Access Compliance Report

Public Rights-of-Way

(Curb Ramps)

Intersection ID: N/A	Main Street: INDEPENDENCE_RD	Cross Street: N/A	Location: NW
ADA ID: 37440259BE49	Ramp Type: Directional1	Initial Pass/Fail: Fail	Overall Compliance: No
		Severity Score: 12.5

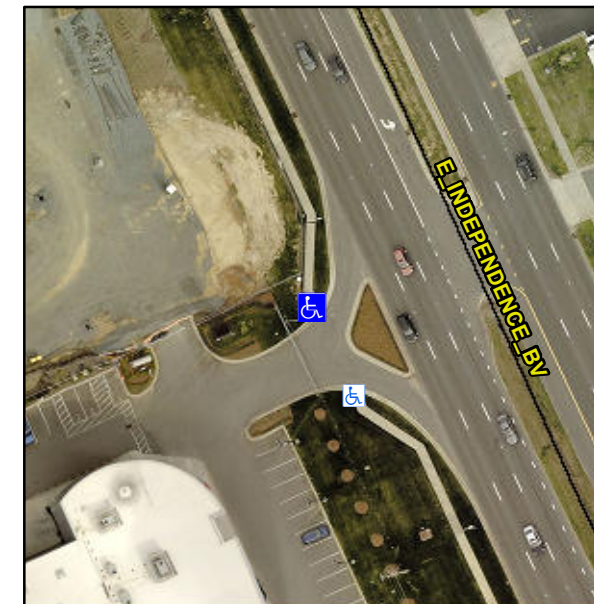
R304.2.2

Compliance	Description	Data	Compliance	Description	Data
N/A	Ramp Length (in)	100.0	N/A	Grade Break?	N/A
Yes	Ramp Width (in)	67.0	N/A	Grade Break Slope (%)	0.0
No	Ramp Slope (%)	10.4	N/A	Grade Break XSlope (%)	0.0
Yes	Ramp XSlope (%)	0.7			
N/A	Flare Type LT	N/A	N/A	Flare Type RT	N/A
N/A	Flare Slope LT (%)	N/A	N/A	Flare Slope RT (%)	0.0
N/A	Flare Traversable LT?	N/A	N/A	Flare Traversable RT?	N/A
N/A	Landing Length (in)	0.0	N/A	DWS Provided?	N/A
N/A	Landing Width (in)	0.0	N/A	DWS Contrast?	N/A
N/A	Landing Slope (%)	0.0	N/A	DWS Length (in)	N/A
N/A	Landing X Slope (%)	0.0	N/A	DWS Full Width?	N/A
N/A	Landing Curb? (Y/N)	N/A	N/A	DWS Offset LT (in)	N/A
N/A	Shared Landing?	N/A	N/A	DWS Offset RT (in)	N/A
N/A	Gutter Ponding?	Yes	N/A	Gutter Slope (%)	N/A
N/A	Gutter Lip Ht (in)	0.0	N/A	Gutter X Slope (%)	N/A
N/A	Painted X Walk1?	No		Road Slope (%)	4.4
	X Walk 1 Direction	To S		Road X Slope (%)	4.4
	X Walk 1 Width (in)	N/A		Clear Space?	N/A

Remove & Replace Entire Ramp.
